## Timing Decal - 1991 and 1992 200 HP Carburetor Models

200 Carburetor Models

S/N 0D077248 thru 0D177258

### Figure 1. Flywheel Cover

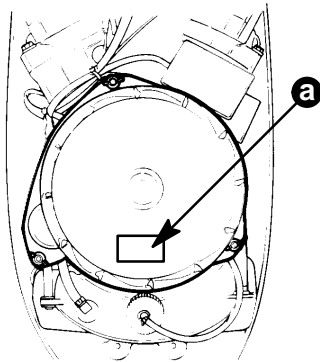
The timing decal p/n 37-818637-34 applied to the flywheel cover on the models listed is incorrect. The information on the decal is for maximum timing and set up for models that are equipped with the combination idle stabilizer/advance module.

The models listed should be equipped with:

- an idle stabilizer module with:  
87076A5 or 87076A9 printed on the module
- timing decal p/n 37-818637-24.

Apply the timing decal p/n 37-818637-24 over the existing timing decal. If you are positive that the maximum timing was not changed from the factory setting, nothing further is required.

If you are not sure or if the timing was changed, check and reset the timing to the new specification. Due to the many variables encountered when setting the maximum timing at cranking, it is recommended to recheck the setting above 5000 RPM.

Timing	Previous	New
Cranking	21° BTDC	22° BTDC
5000 RPM	25° BTDC	20° BTDC
